March 13, 2018

**RE: Ravenswood-Cooley Landing 115 kV Reconductoring Project (A. 17-12-010)  
Response to California Public Utilities Commission Data Request No.1**

**Attachment 1**  
**PG&E Responses to Data Request No. 1**

# Cooley Landing – General Arrangement Outdoors

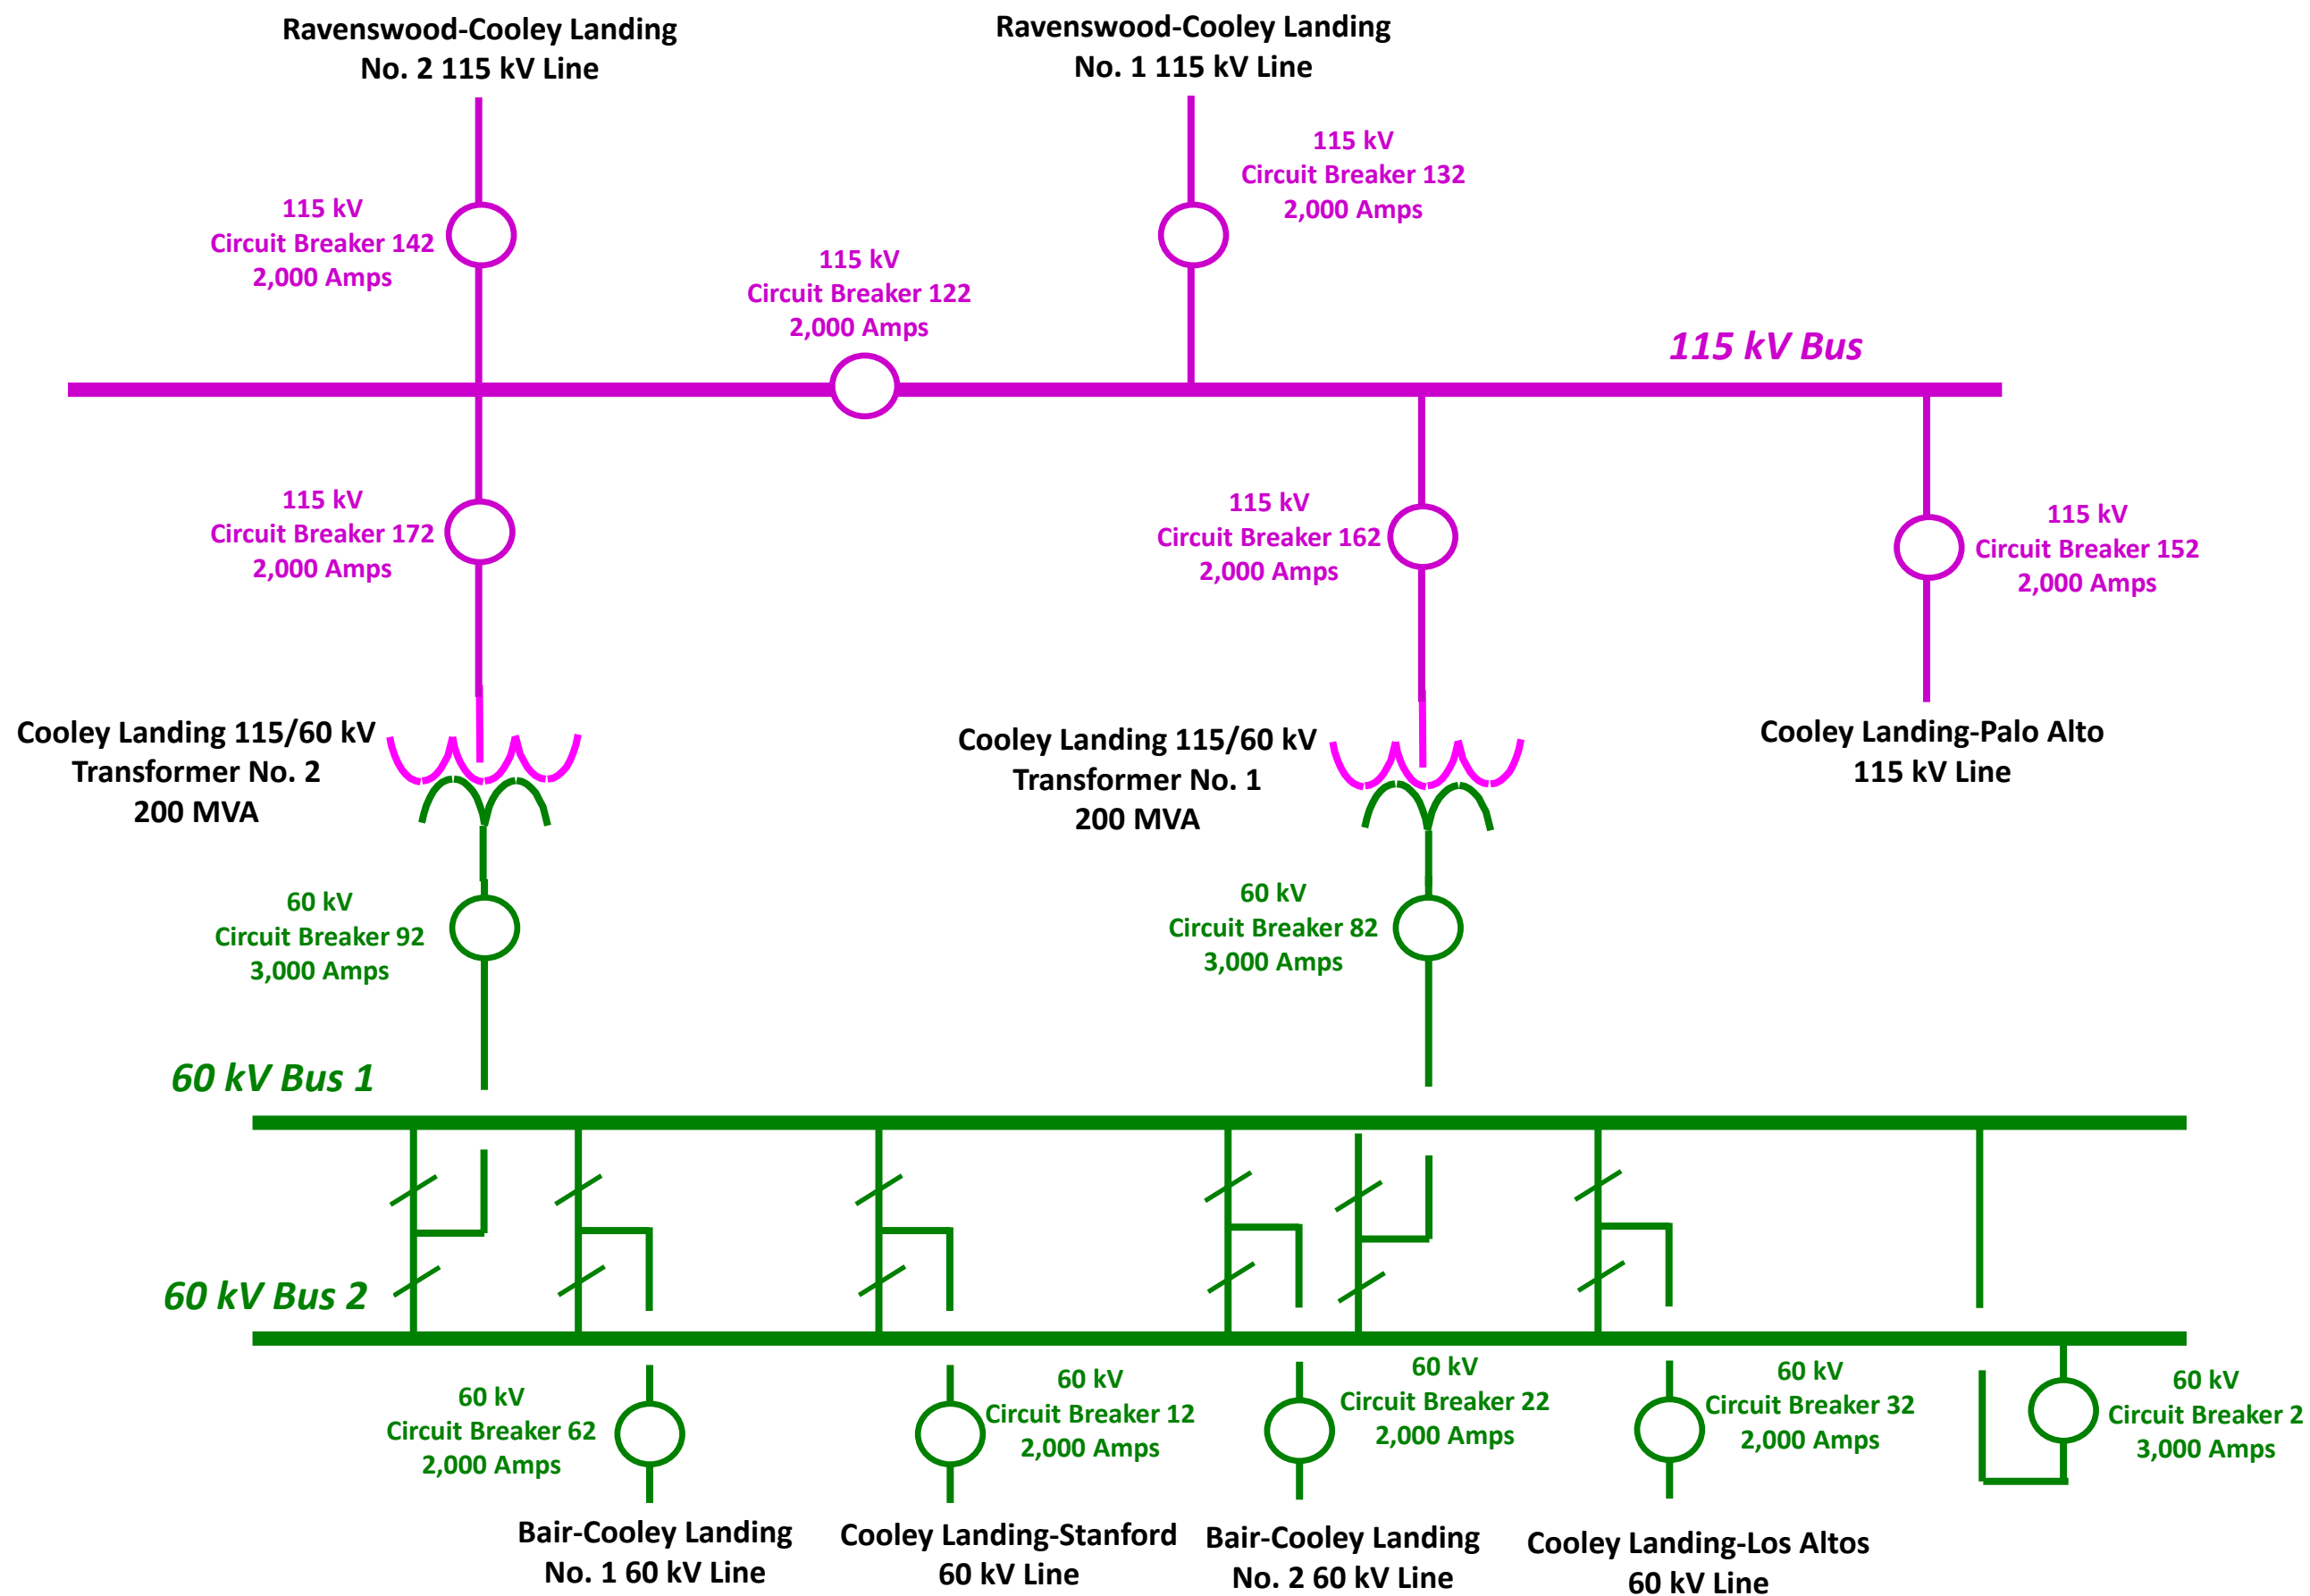
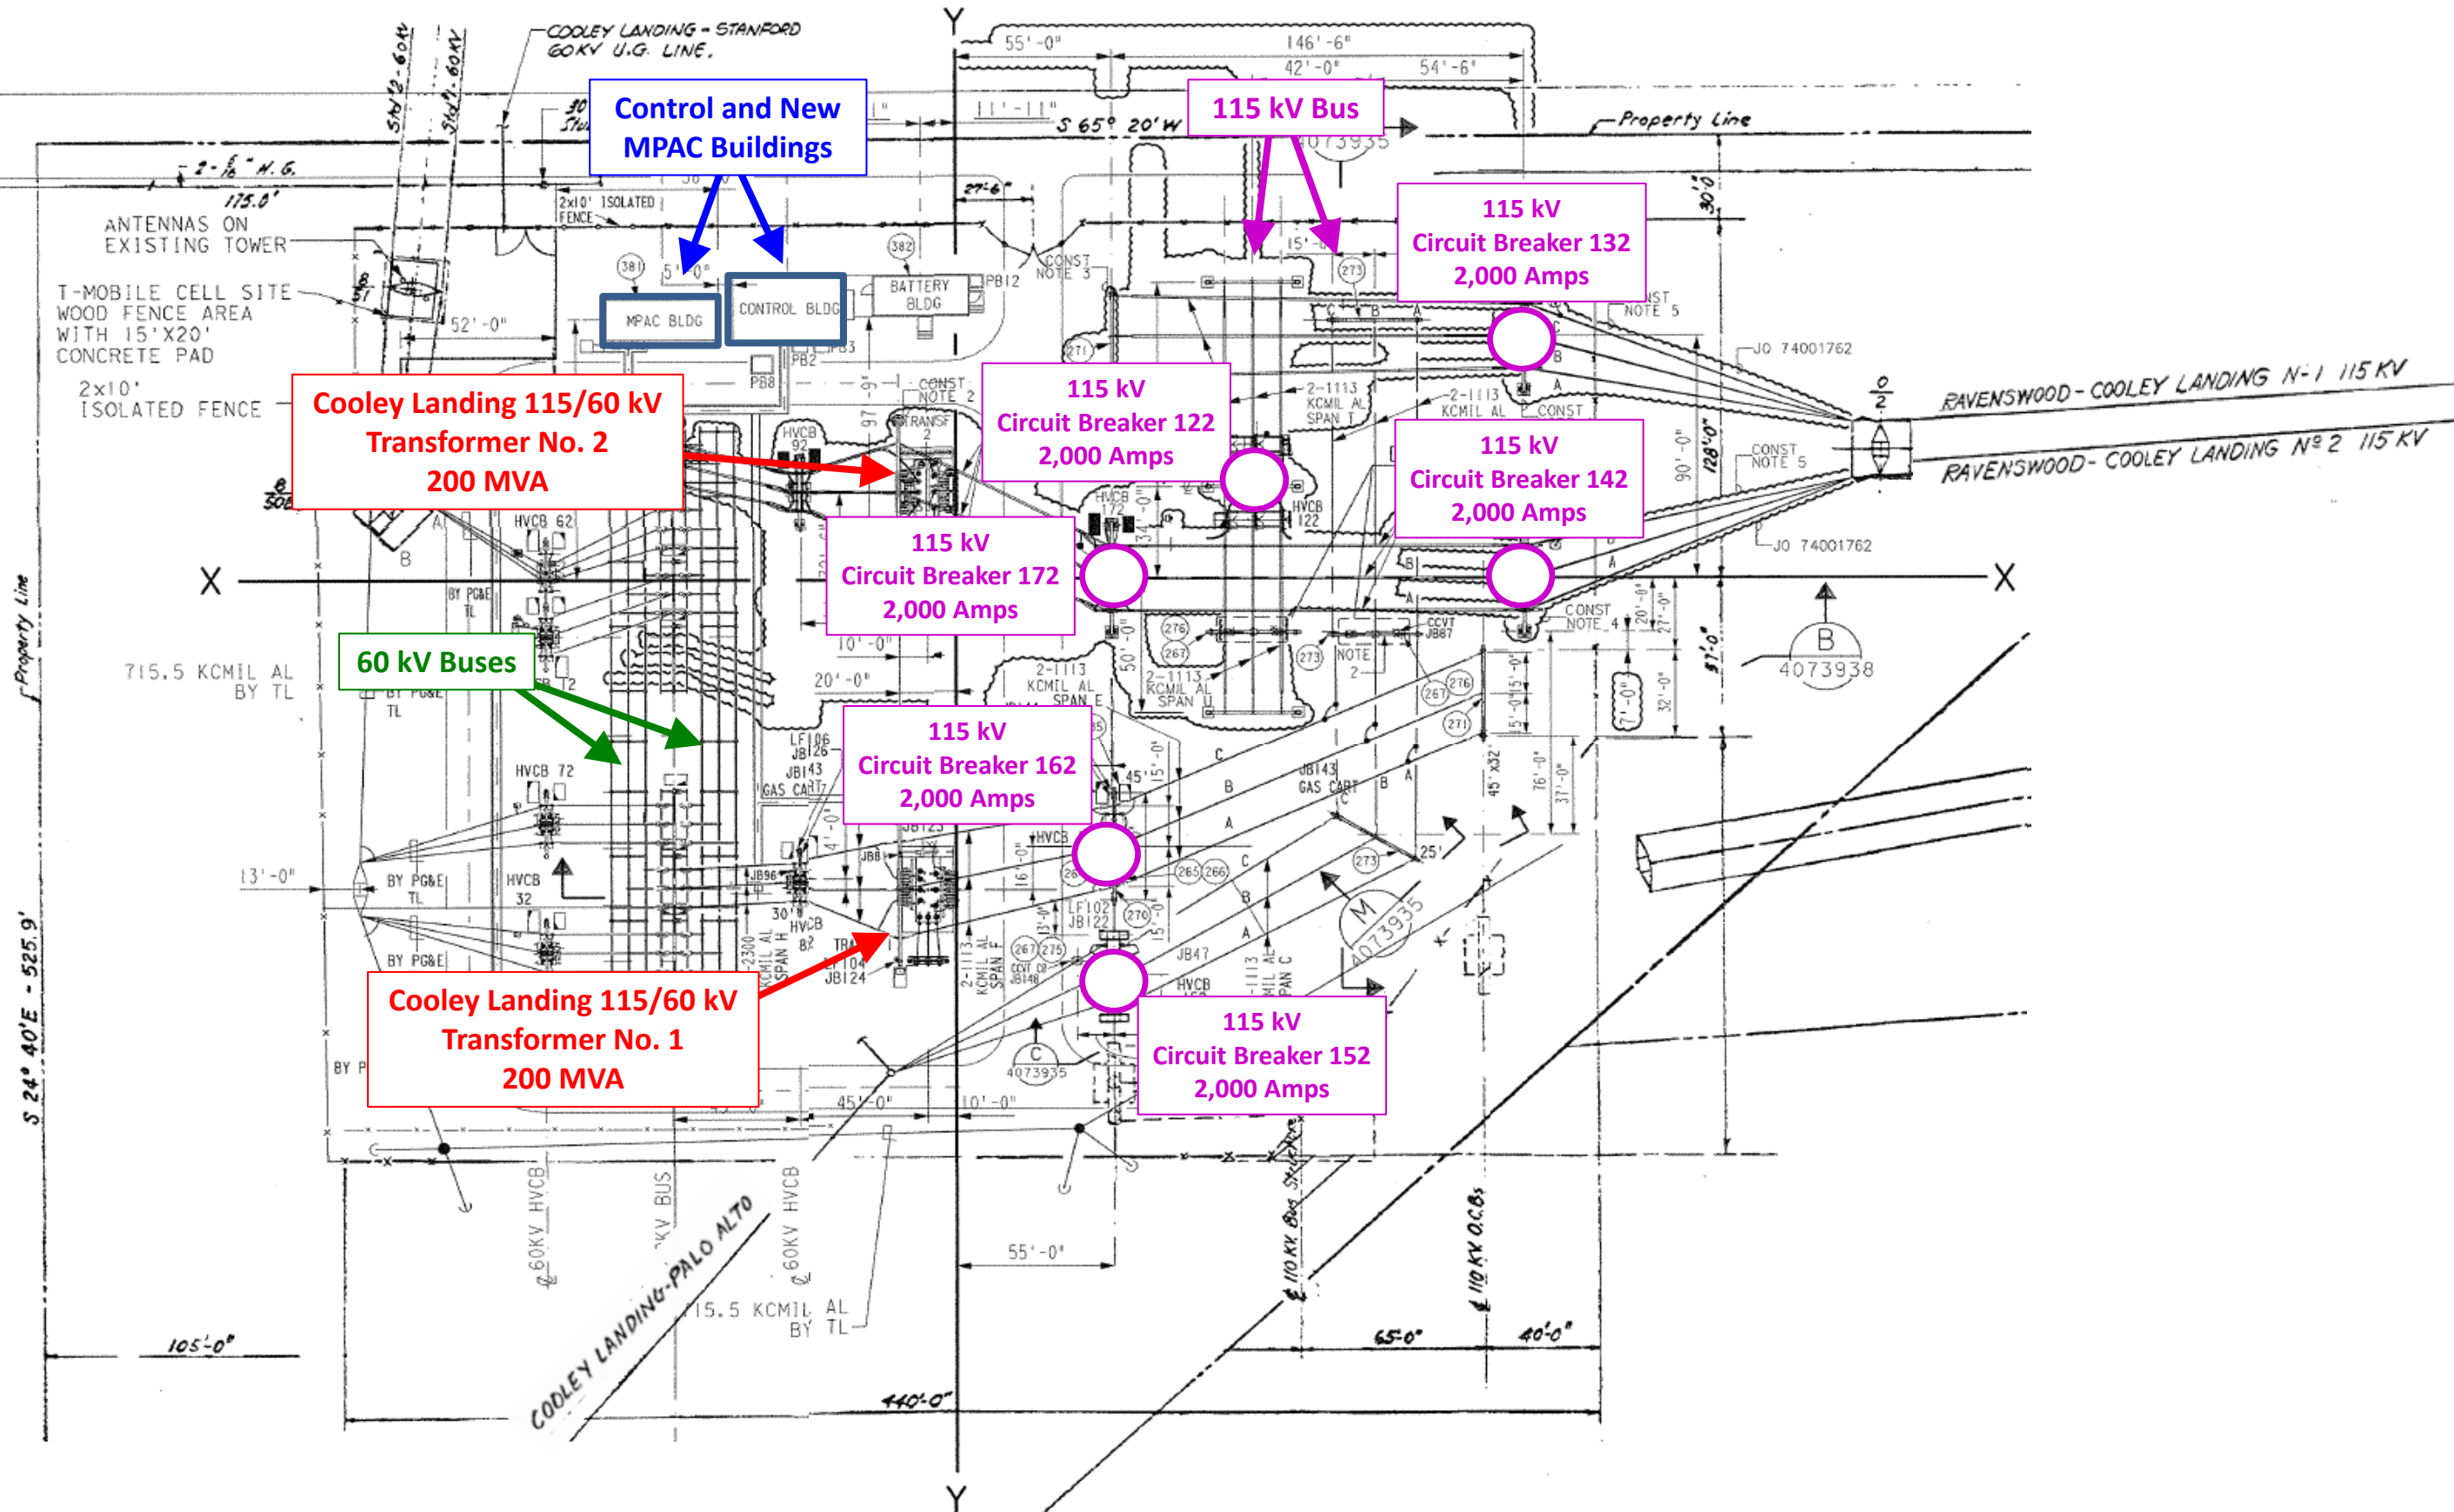
**PD-3** PEA Section 2.5.5 discusses a modification will be required in the Cooley Landing Substation. Please provide one-line diagrams of the Cooley-Landing substation. Please show bay arrangements and breaker ratings.

**PG&E Response:** Please refer to Attachment 6 for the single-line diagram of Cooley Landing Substation showing the breaker ratings, the general arrangement map showing the locations of existing bay arrangements and existing Circuit Breaker 122,

and the new optical fiber ground wire (OPGW) line termination point at the existing control building.
